Application for Variation of an Environmental Permit

C2. Application No. of the Current Environmental Permit : FEP-196/2019

Hong Kong Offshore LNG Terminal Project

Proposal of BPPS Pipelaying and Rock Armour Placement at Night
At the Restricted Area

For Anchor Model Lay Barge (Option 1)

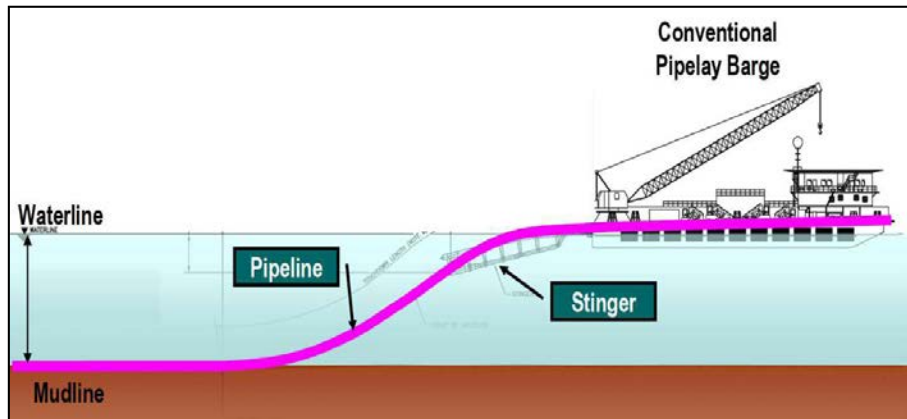
The anchor model barge and DP model barge are two options for pipelaying, there will be only anchor model lay barge used at the restricted area and it will be used in the restricted area all the time without change.

All anchoring works will be suspended from 1900 hours to 0700 hours of the following day and just carry out the simple pipelaying at night.

Laybarge will carry out normal pipelaying deck works which include lifting pipes to transition roller; preparation works include welding, moving barge as described in justification.

For Dynamic Positioning (DP) Model Lay Barge (Option 2)

Laybarge will carry out normal pipelaying deck works which include lifting pipes to transition roller; preparation work include welding; moving barge as described in justification.

Rock Armour Placement Works

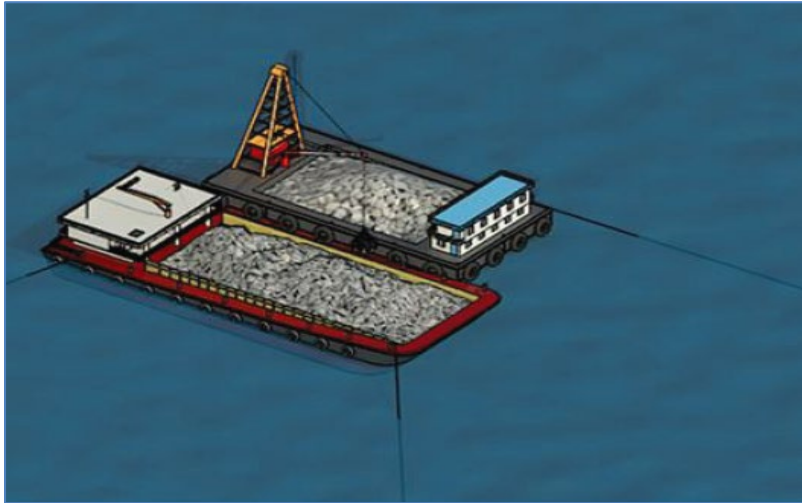
- Derrick barge will carry out normal rock armour placement works which include material transfer; barge positioning, and rock armour placement.
